HMA Resurfacing/Cold-in-Place Recycling
NHSX-030-2(182)--3H-14

CARROLL COUNTY

PLANS OF PROPOSED IMPROVEMENT ON THE
PRIMARY ROAD SYSTEM
CARROLL COUNTY
HMA Resurfacing/Cold-in-Place Recycling
0.2 mi W of Zephyr Ave to IA 25

PRELIMINARY PLANS

ML - US30

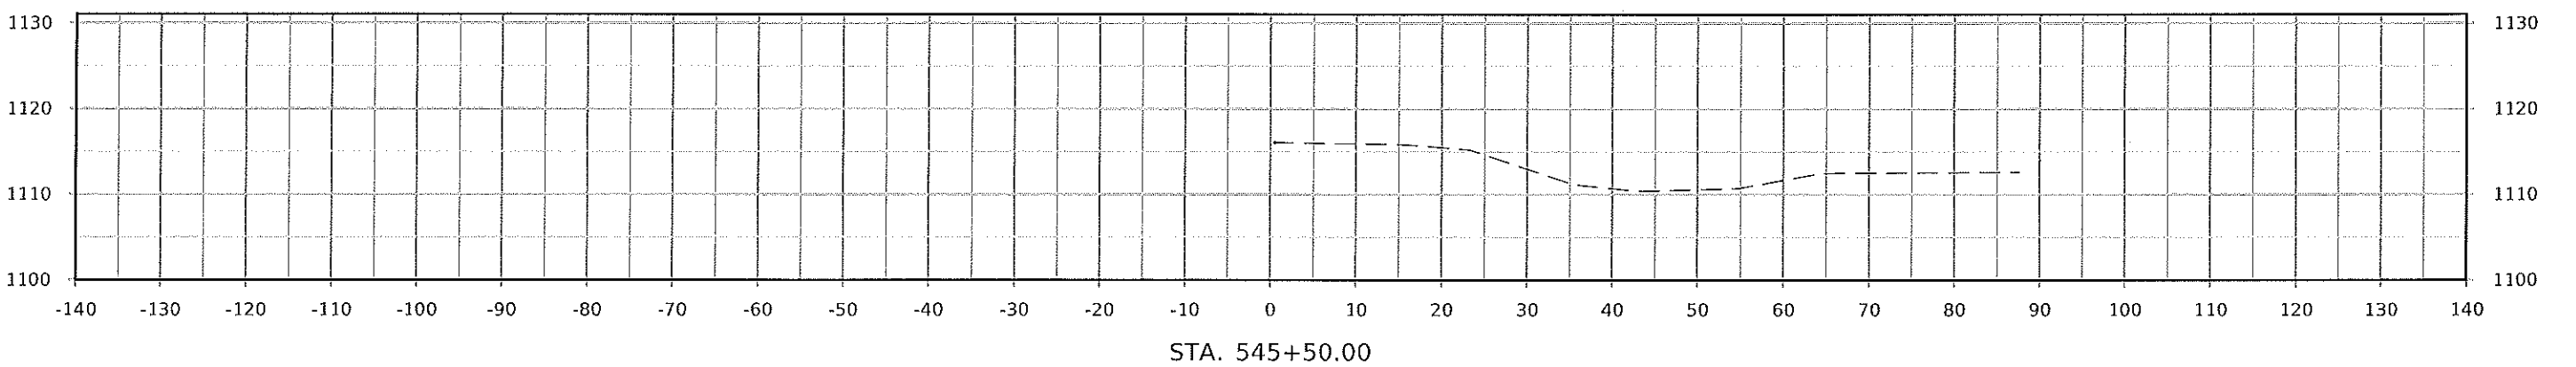
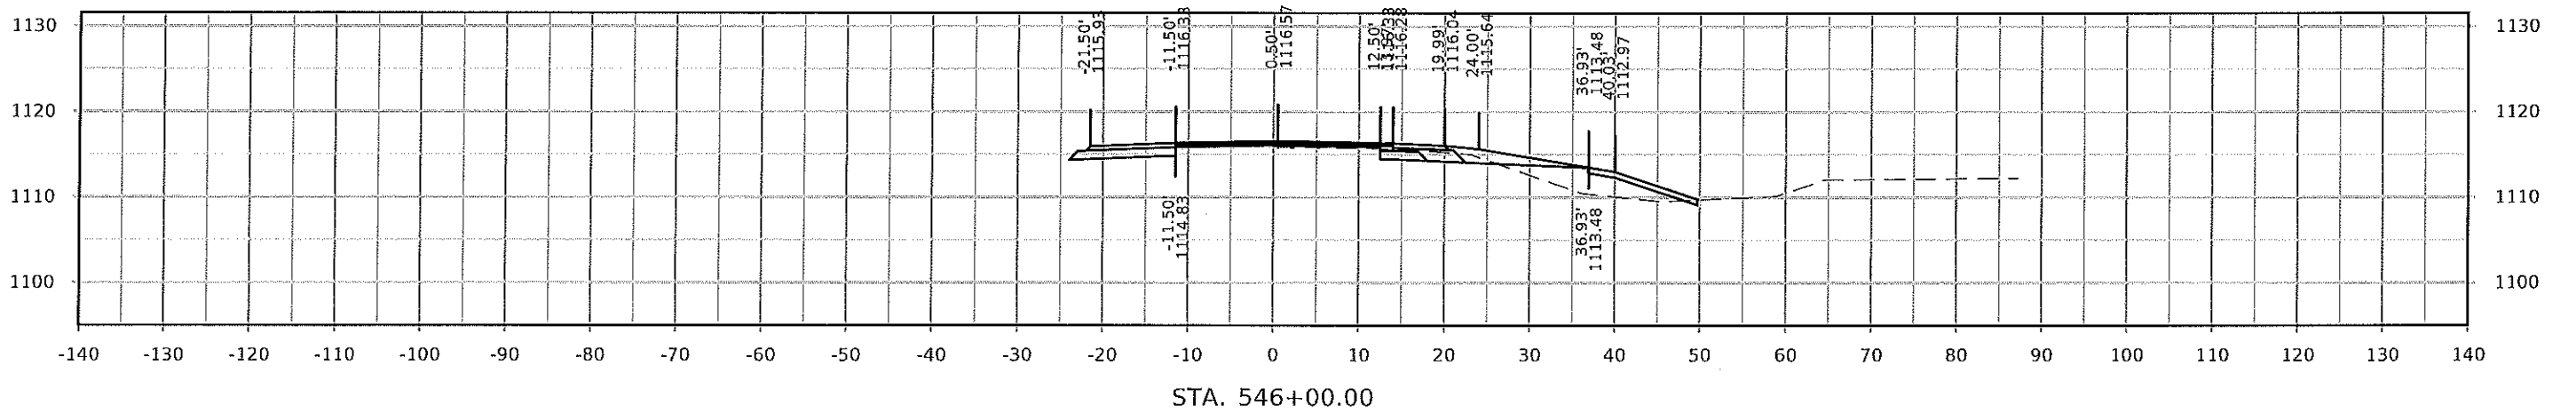
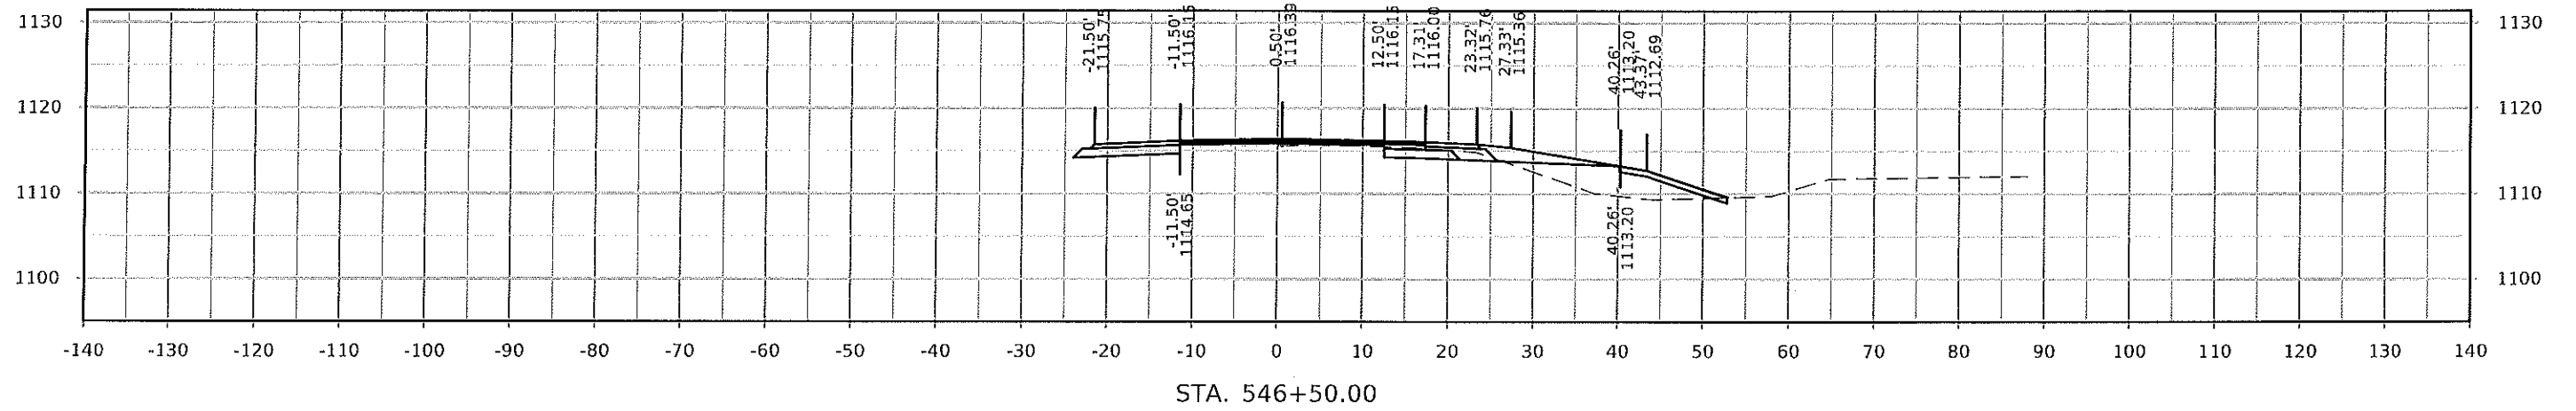
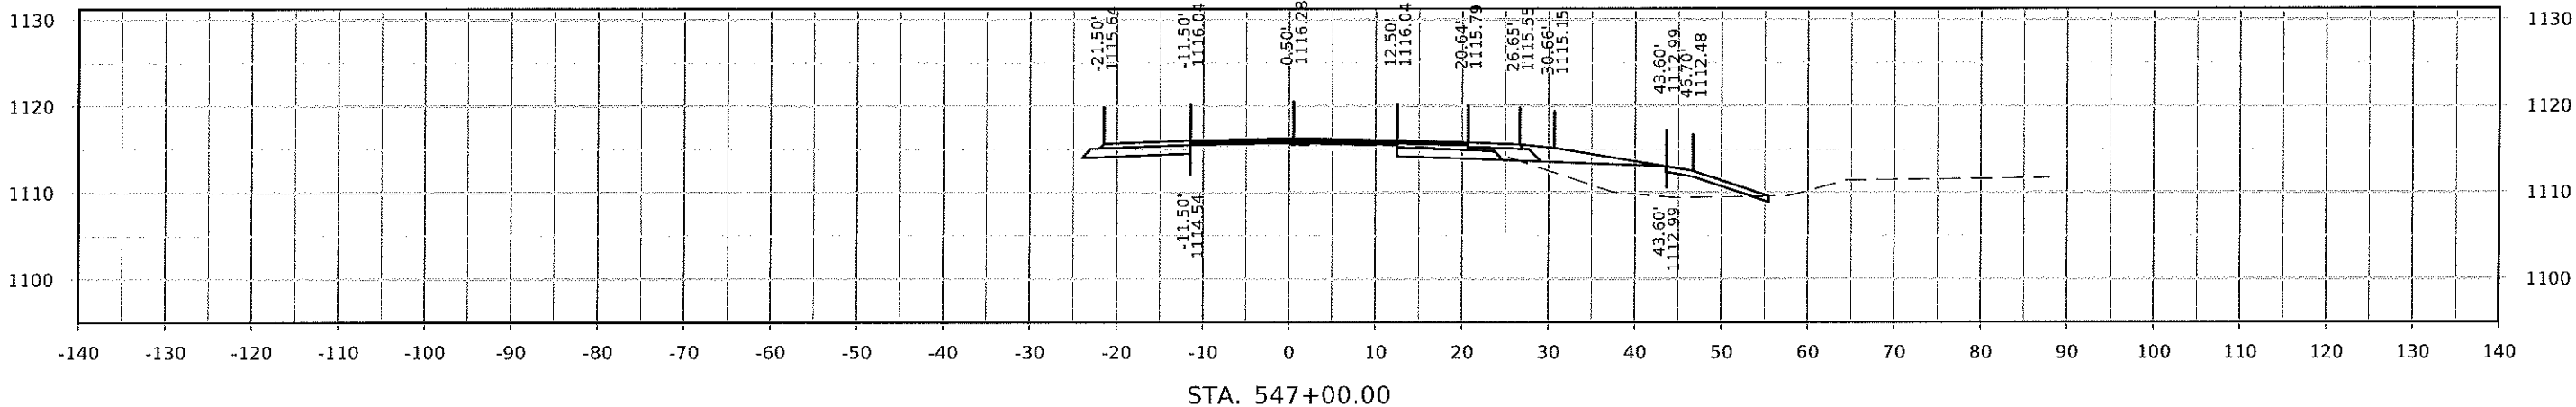
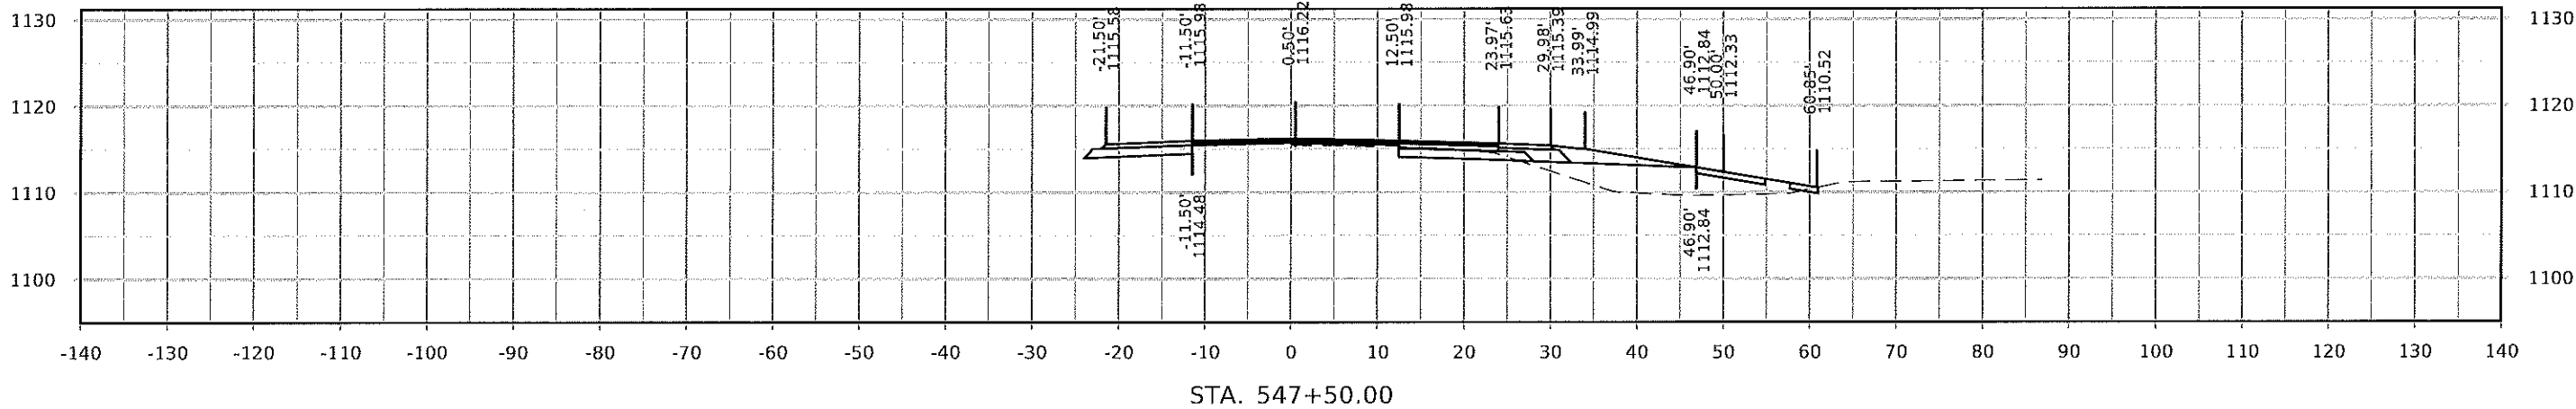
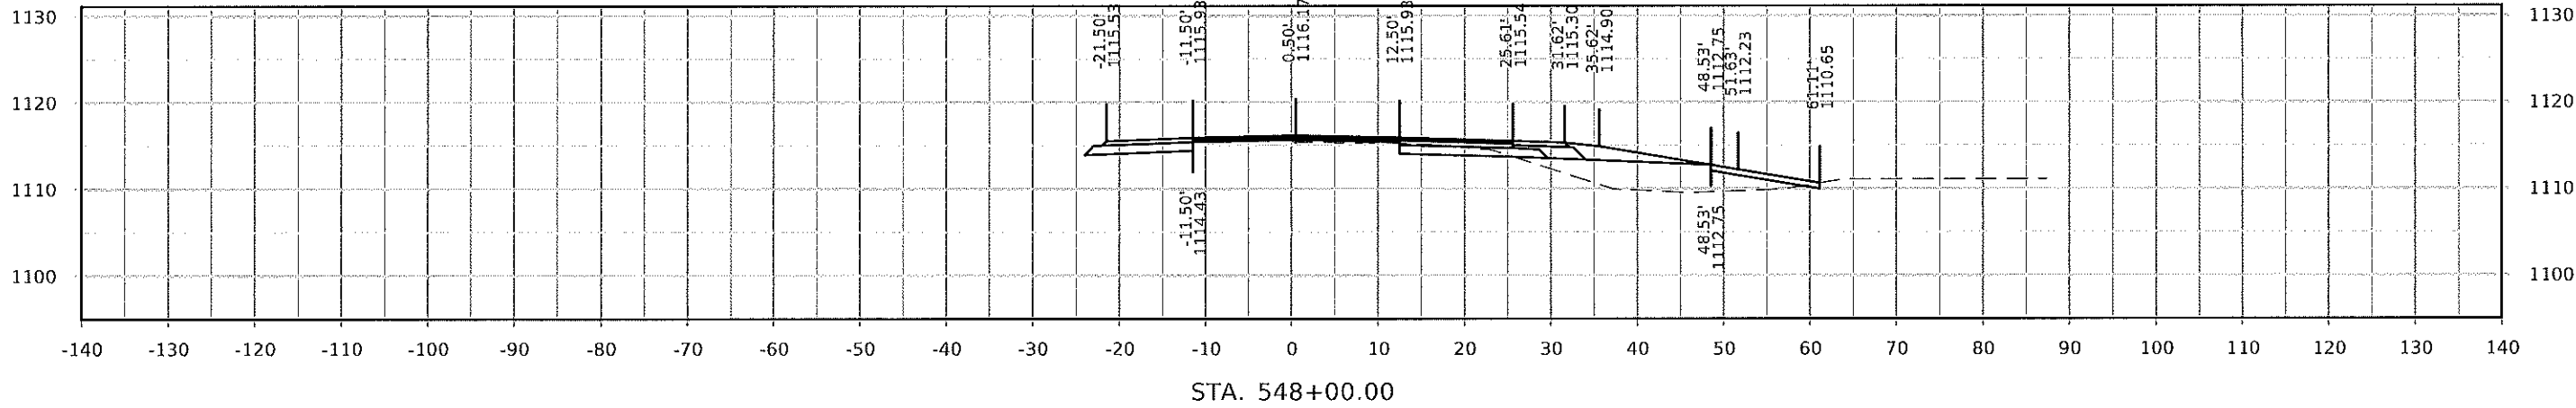
Add
Distal
Grades
